TSB # 842-0040
Prince Castle
355 East Kehoe Blvd
Carol Stream, IL 60188

In a going effort to ensure quality on our Genuine OEM Equipment we are Issuing a TSB for our UHC Holding Cabinet Series. This TSB Indicates ribbon cable supersedes of OEM Part #'s 95-1834 & 95-1835. These will be replaced by OEM Part #'s 95-2041 & 95-2042. These New Ribbon Cables will increase cable lifespan to improve overall reliability.

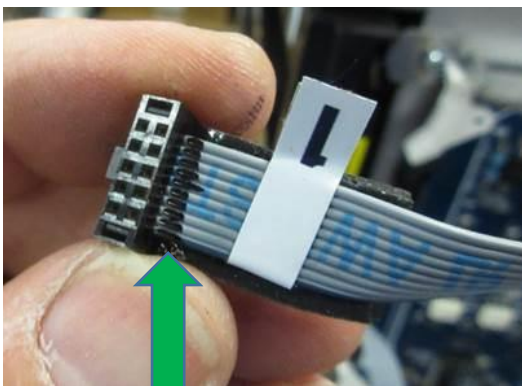
Cable Differences and Unit Identifier:

- Units will have either black or green marking indicators depicted below

NO COATING OLD REV

HAS COATING NEW REV
